CITY OF FRANKLIN
PLAN COMMISSION MEETING*
FRANKLIN CITY HALL COUNCIL CHAMBERS
9229 W. LOOMIS ROAD, FRANKLIN, WISCONSIN
AGENDA
THURSDAY, MARCH 3, 2022, 7:00 P.M.

City of Franklin
Plan Commission Meeting
February 17, 2022
Minutes

CITY OF FRANKLIN
REPORT TO THE PLAN COMMISSION

SHEET C-1
CONCEPT PLAN
 © COPYRIGHT 2019

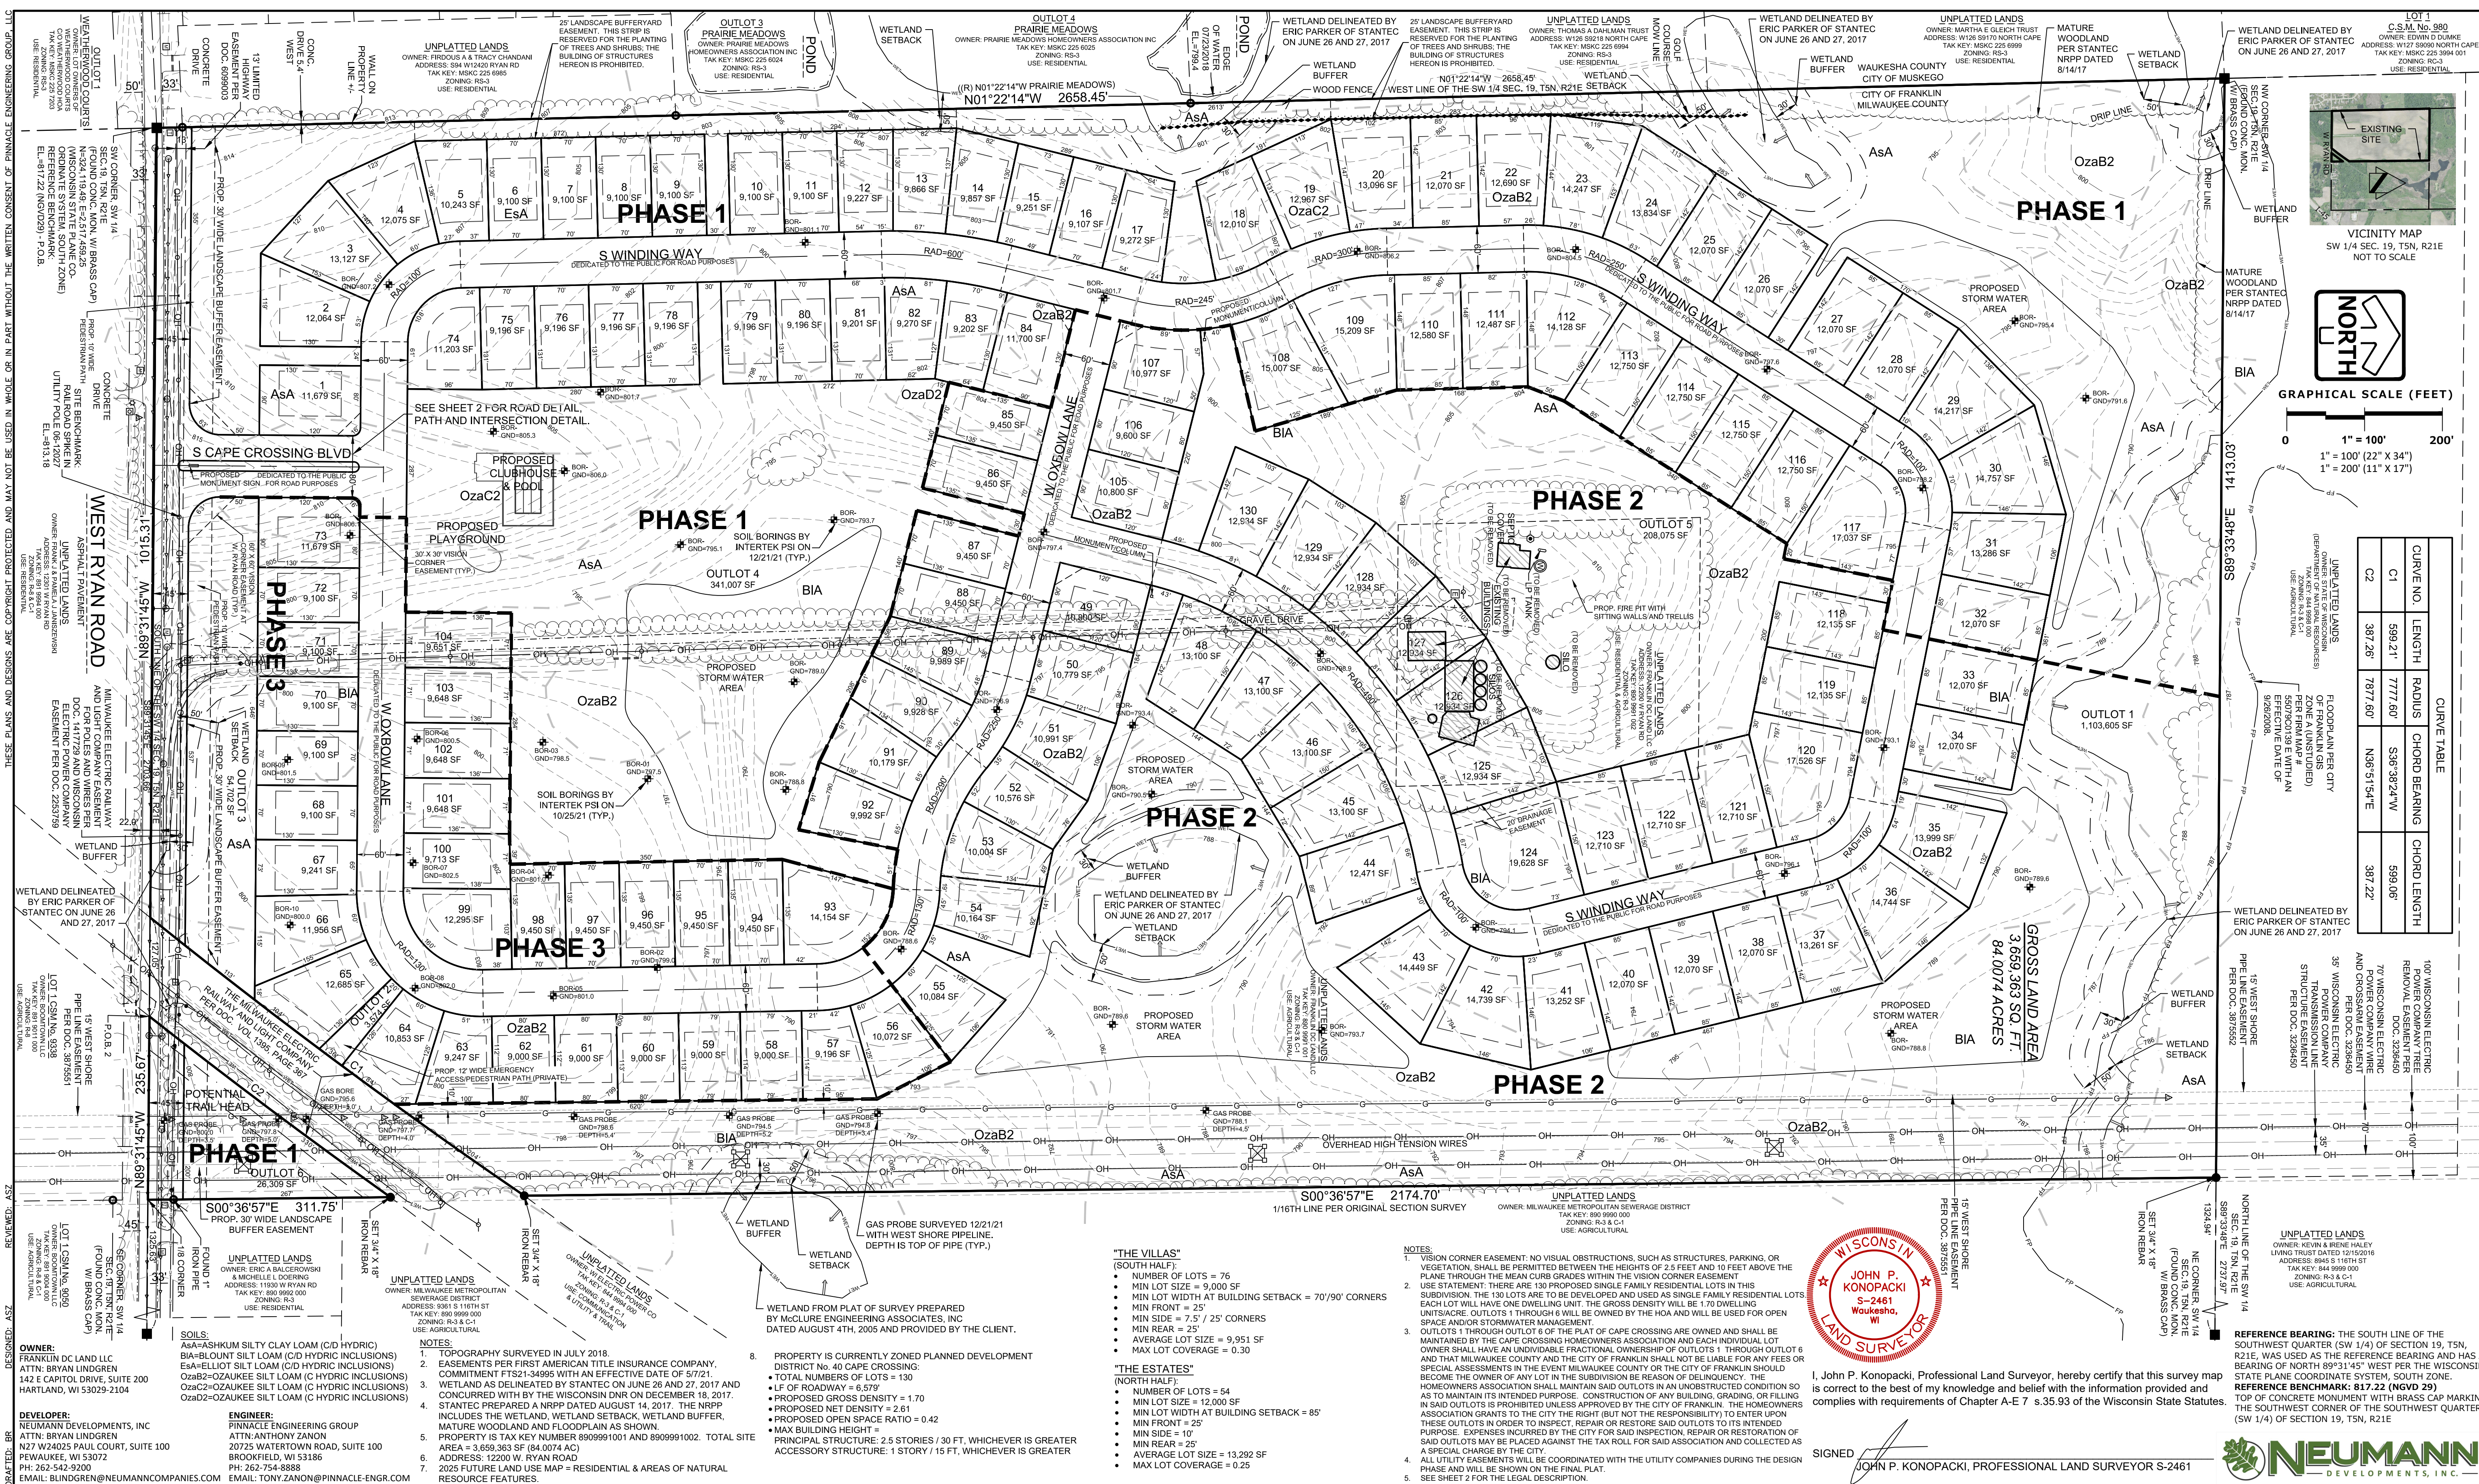
3. **Acceleration and deceleration lanes.** Per the recommendations of the Traffic Impact Analysis prepared by TADI dated November 16, 2021, acceleration and deceleration lanes are recommended at the intersection of Ryan Road and Road “A”, please provide detail of this intersection. **These were shown on the preliminary civil plans. A detail was now added to the preliminary plat on sheet 2.**

SHEET C-3

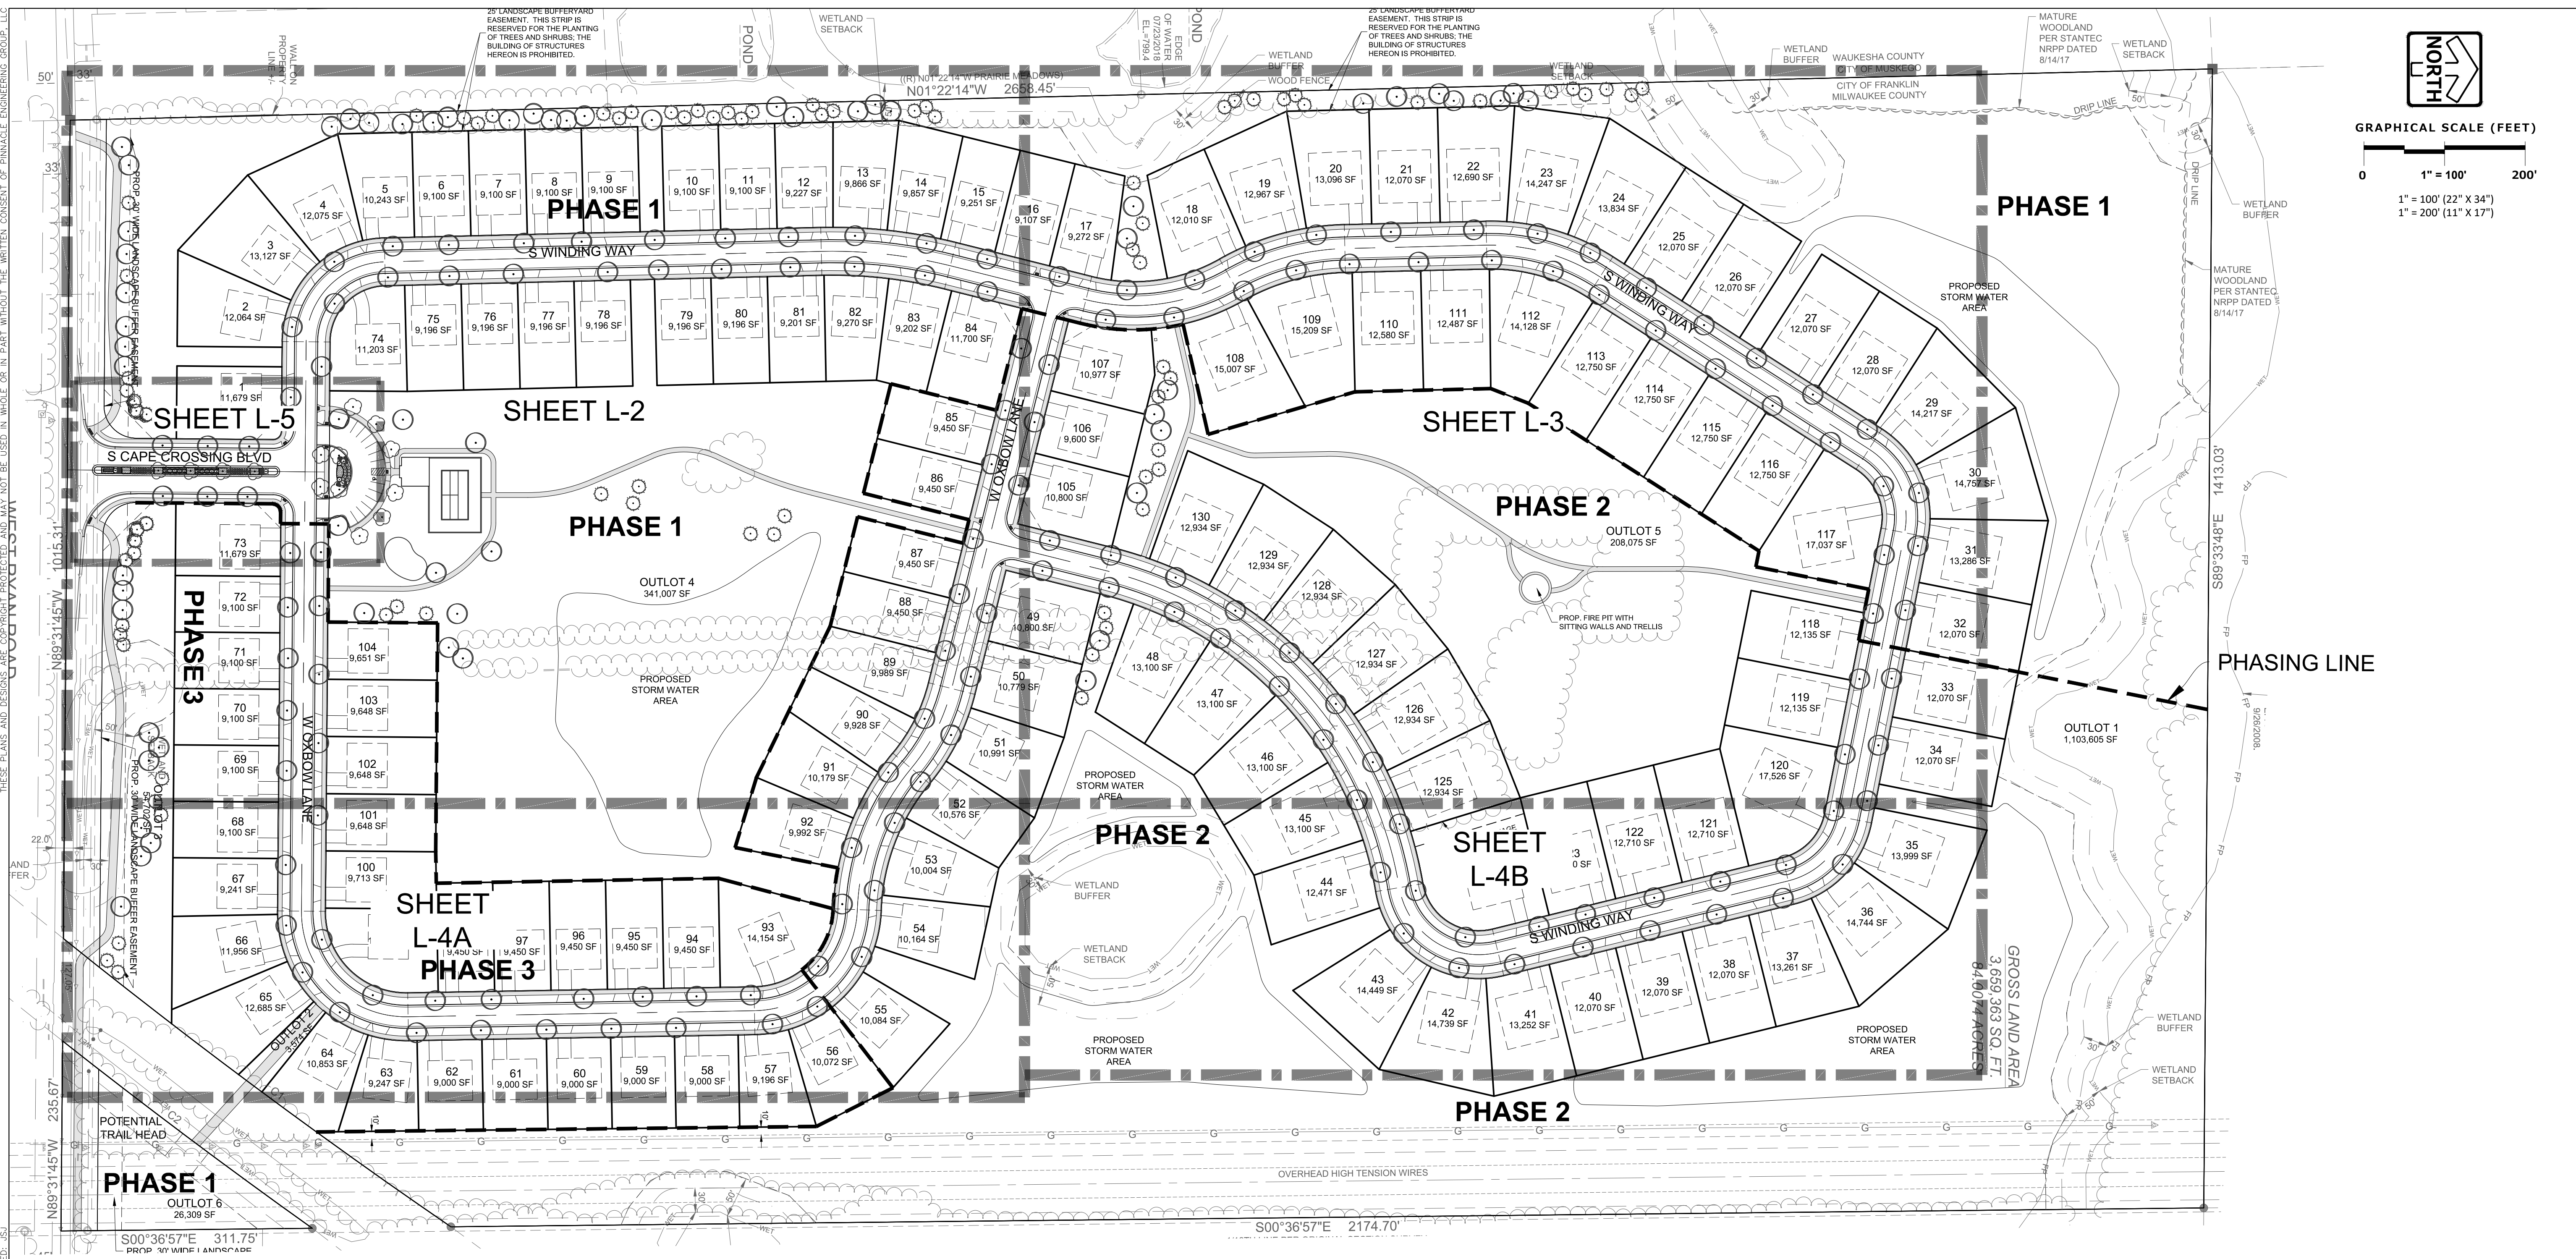
4. **Existing and proposed contours.** Pursuant to subsection C, please depict the proposed contours at vertical intervals of not more than two feet, within the exterior boundaries of the Preliminary Plat and extending to the centerline of adjacent public streets. For clarity, you can add a second sheet to the Preliminary Plat. **The existing and proposed contours are now shown on sheet 3.**

City Development staff recommends to depict the 30-foot wetland buffer and the limit of disturbance line with the proposed contours to attest that the wetland buffers would not be disturbed. **The natural resources are shaded on sheet 3 of the plat. Proposed conservation easements are also shown on sheet 3. See note 13 below for additional information.**

5. **Street grades.** Please add the proposed street grades to attest compliance with the maximum street grades set forth in UDO §15-5.0103.D: 6% for collector and minor streets (Roads “A” & “B”), and 8% for pedestrian ways within outlots. **Proposed street and pedestrian grades are labeled on sheet 3.**

6. **Existing Street Pavements.** Per subsection G, please add the following information for Ryan Road: “Type, width, and elevation of any existing street pavements within the exterior boundaries of the plat or immediately adjacent thereto together with any legally established centerline elevation, all to mean sea level (National Geodetic Vertical Datum of 1929)”. **This information is shown on sheet 3.**

SHEET
C-13
C-22

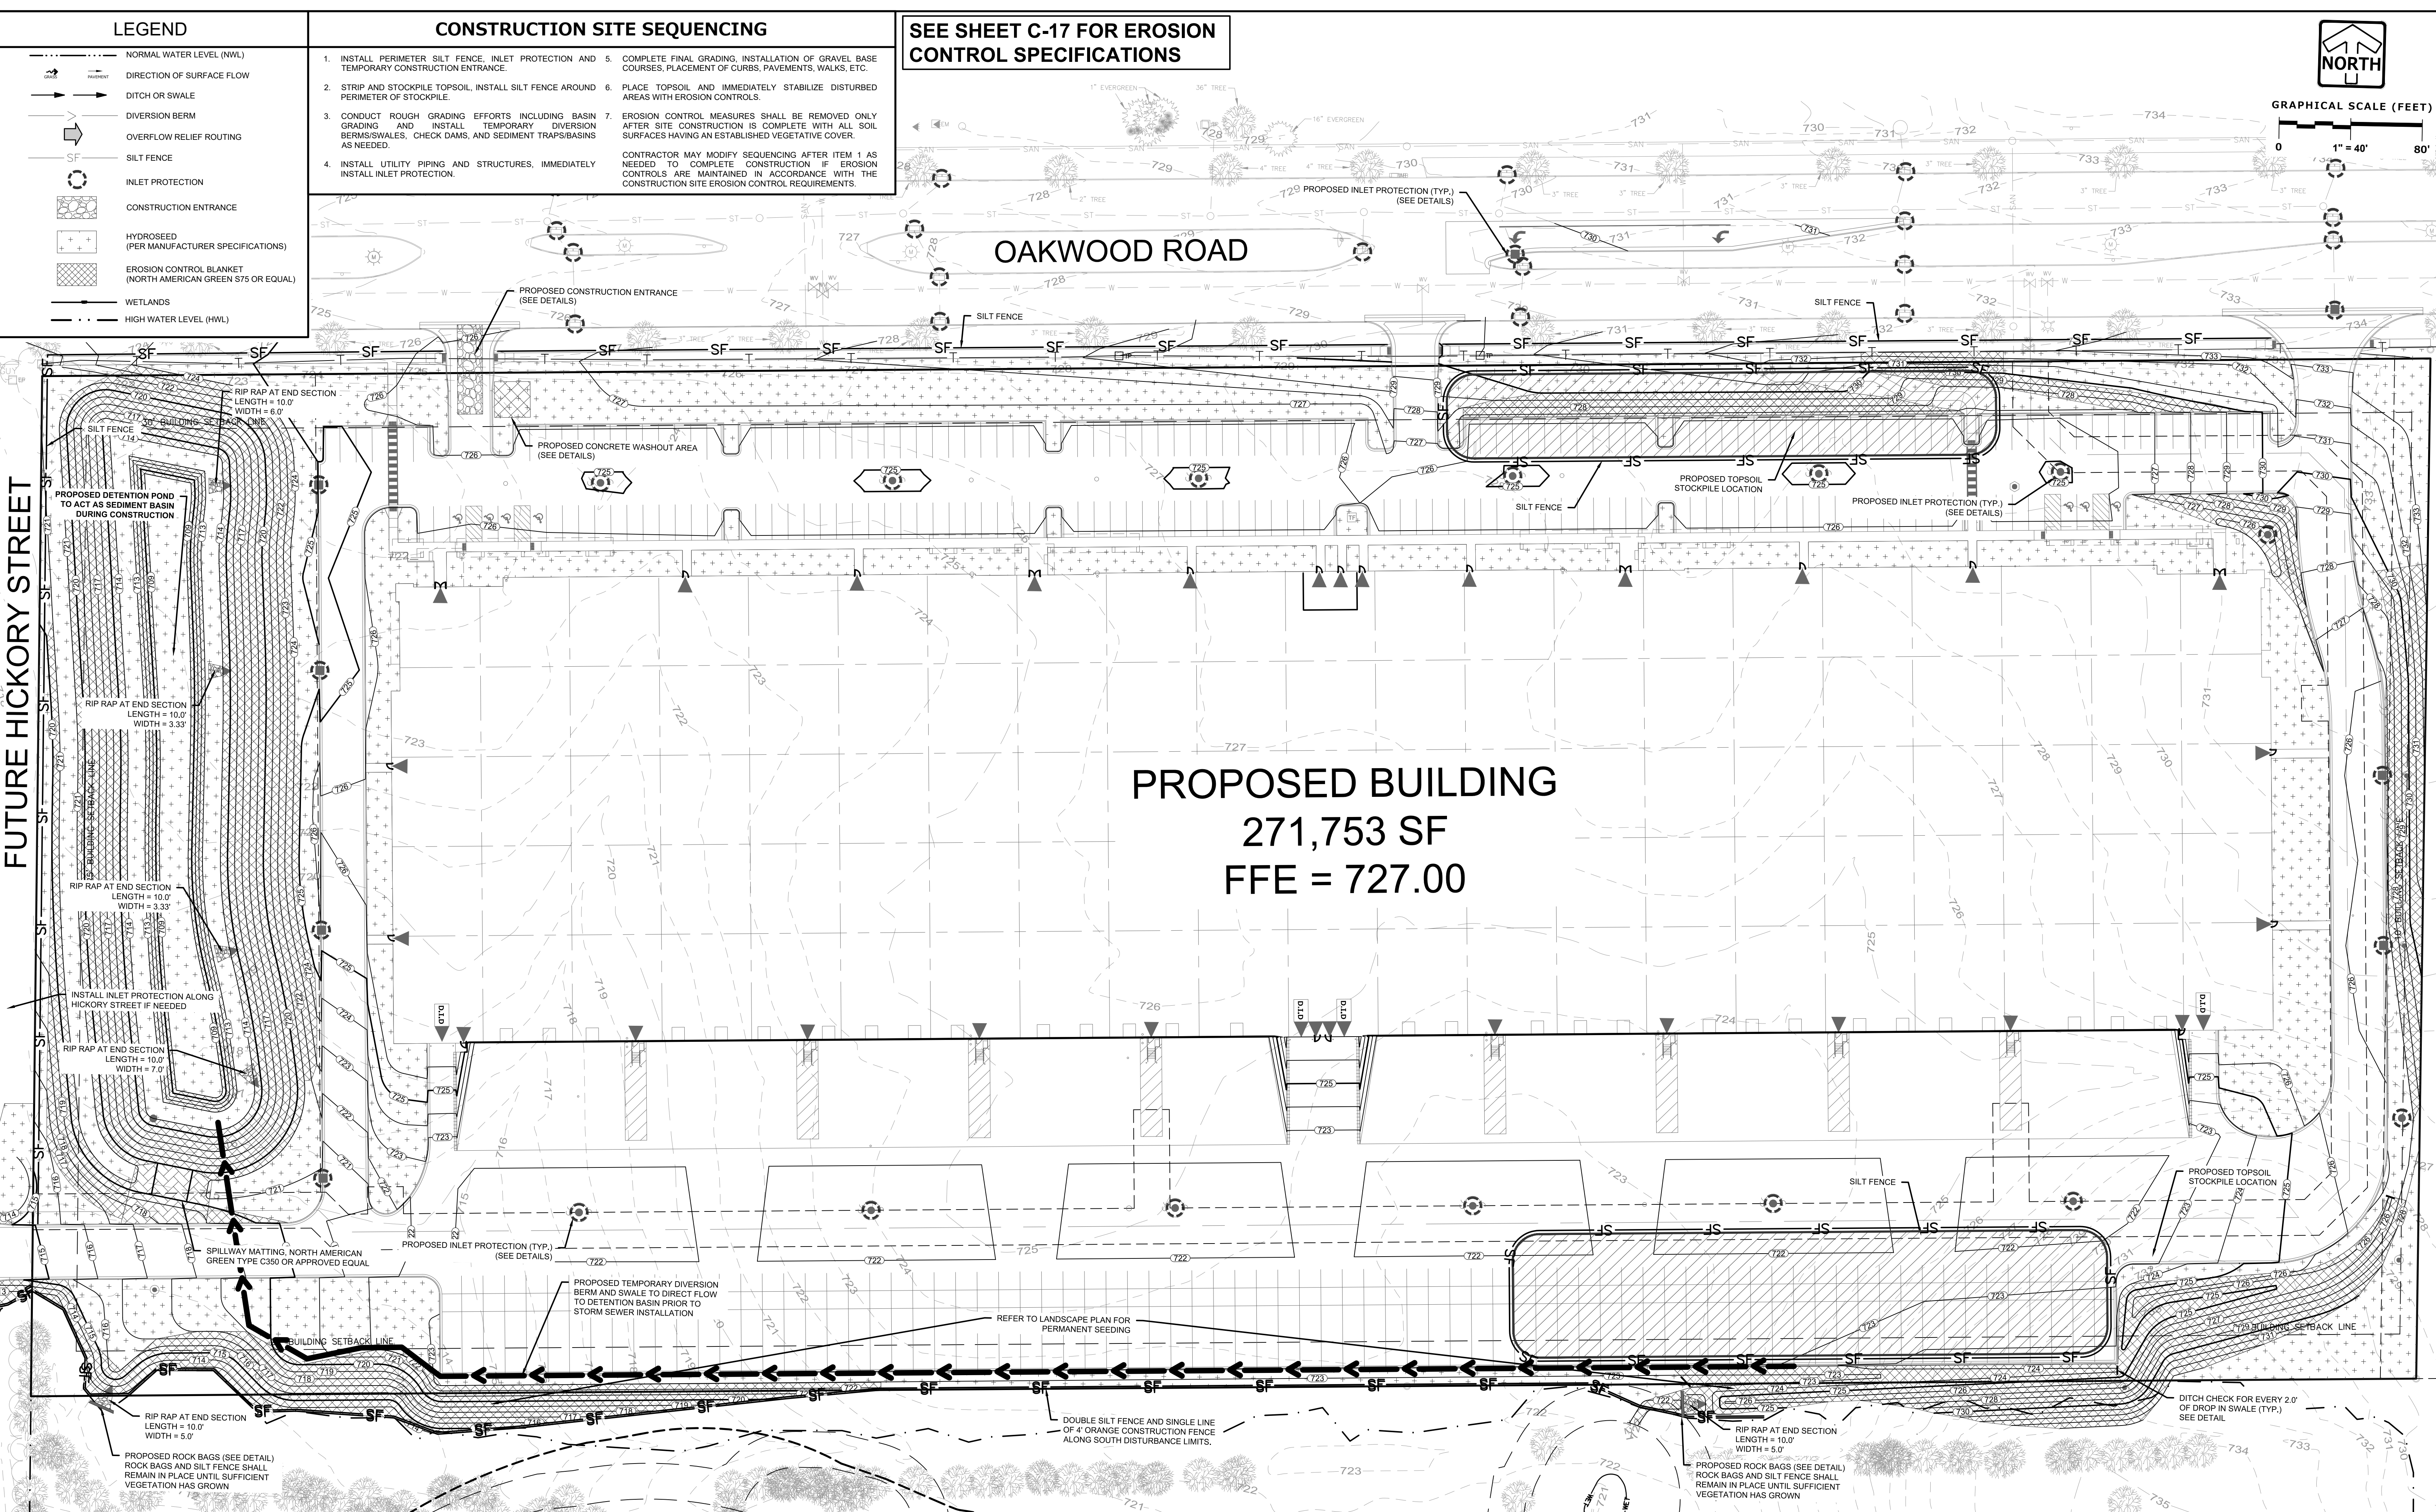
- Added call out to specify double silt fence and construction fence along south disturbance limits on Sheet C-13. Silt fence not necessary at southeast corner as this area is higher and drains into the site.

24. Show proposed approximate location and dimensions of material stockpiles and necessary erosion control measures
 - Added 2 stockpile locations, one to the north and one to the southeast with silt fence on Sheet C-13
25. Any storm sewer in ROW must be reinforced concrete pipe
 - Currently, no new storm pipe is proposed in the ROW. Only some storm structure work.
